# **Proposed changes to the EEC UN Regulations 29**

**10-11 April 2007  
Lion**

## 180° rollover – OICA proposal

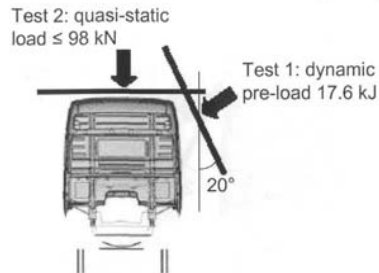
Test 1 - dynamic pre-deformation:

- Rigid platen
- Inclined 20° to the vertical
- Energy level: 17.6 kJ
- Direction of the impact: perpendicular to the longitudinal axis of the cab

Test 2 – quasi-static load:

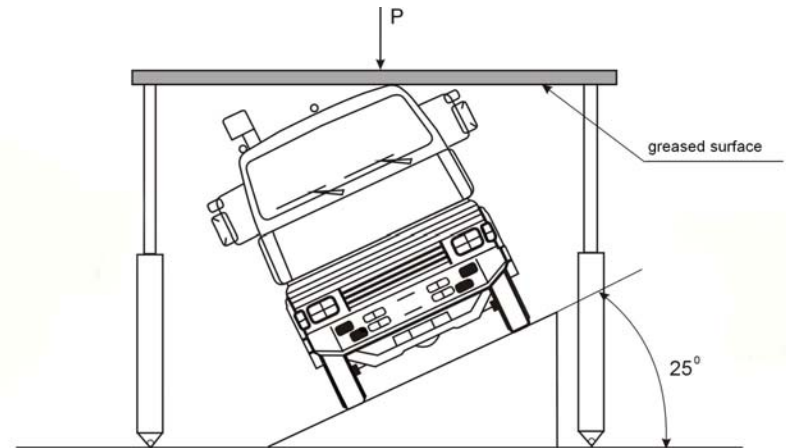
- On same cab as test 1
- Rigid platen
- Force = maximum authorised load front axle(s), ≤ 98 kN
- Direction of the load: vertical

$$P = [K] \times PCH \leq 10T,$$

where PCH – full load of the vehicle that falls to the front axle;

K – dynamic load coefficient.

# Back part strength testing (Test C – A-pillar test)

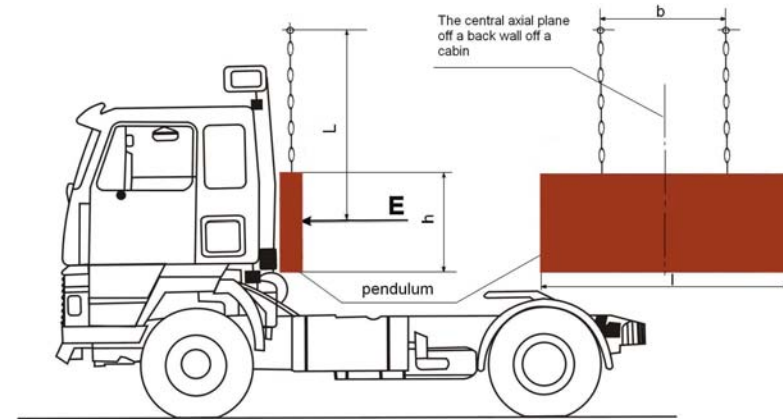
90° rollover with subsequent impact (A-pillar test) – to be included in UNECE R29:

- Steel pendulum  $\geq 1,000$  kg
- Inclined  $45^\circ$  to vertical,  $15^\circ$  in horizontal XZ plane
- Impact direction:  $15^\circ$  to vehicle longitudinal axis
- Impact energy 30 kJ

- for N1 Category – [15] kJ
- for N2 Category – [20] kJ
- for N3 Category – 30 kJ

- dimensions:  $h=500$  mm;  $l=1600$  mm
- weight  $m = 1000$ kg

- the center of the strike must coincide with the central axial plane of the back wall and be located in the middle between the floor and the roof of the cabin;
- chain-hanged pendulum,  $L \geq 3500$  mm,  $b \geq 800$  mm
